Access Compliance Report

Public Rights-of-Way

Intersection ID: 53001	Main Street: GRANT_MARTIN_DR	Cross Street: JACOB_ALEXANDER_CT	Location: E
ADA ID: 1EBB8E3A36CE	Ramp Type: PerpDiag	Initial Pass/Fail: Fail	Overall Compliance: No
		Severity Score: 10

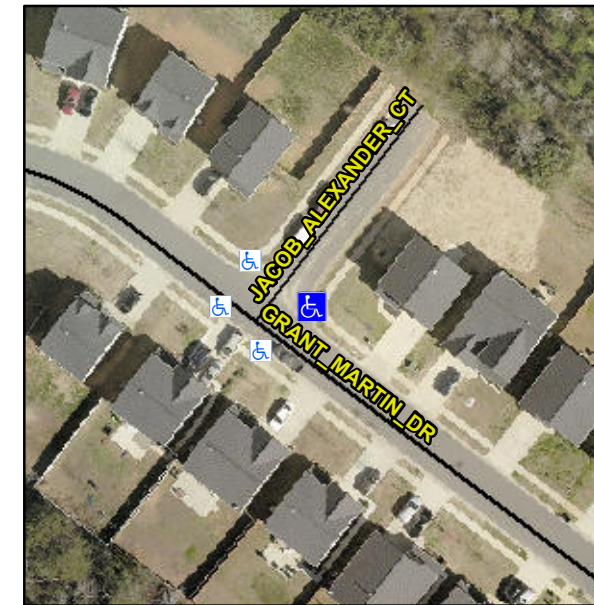
Not Found, R304.5.1, R304.5.3

Compliance	Description	Data	Compliance	Description	Data
N/A	Ramp Length (in)	51.0	Yes	Ramp Slope (%)	7.4
No	Ramp Width (in)	47.5	No	Ramp XSlope (%)	2.9
N/A	Flare Type LT	N/A	N/A	Flare Type RT	N/A
N/A	Flare Slope LT (%)	N/A	N/A	Flare Slope RT (%)	N/A
N/A	Flare Traversable LT?	N/A	N/A	Flare Traversable RT?	N/A
N/A	Landing Length (in)	N/A	N/A	DWS Provided?	N/A
N/A	Landing Width (in)	N/A	N/A	DWS Contrast?	N/A
N/A	Landing Slope (%)	N/A	N/A	DWS Length (in)	N/A
N/A	Landing X Slope (%)	N/A	N/A	DWS Full Width?	N/A
N/A	Landing Curb? (Y/N)	N/A	N/A	DWS Offset (in)	N/A
N/A	Shared Landing?	N/A			
N/A	Gutter Ponding?	N/A	N/A	Gutter Slope (%)	N/A
N/A	Gutter Lip Ht (in)	N/A	N/A	Gutter X Slope (%)	N/A
N/A	Painted X Walk1?	No	N/A	Painted X Walk2?	No
	X Walk 1 Direction	To NW		X Walk 2 Direction	To SW
N/A	X Walk 1 Width (in)	N/A	N/A	X Walk 2 Width (in)	N/A
	X Walk 1 Slope (%)	2.0		X Walk 2 Slope (%)	3.2
	X Walk 1 X Slope (%)	2.2		X Walk 2 X Slope (%)	2.4

Remove & Replace Curb Ramp With Two New Directional Ramps or Equivalent.
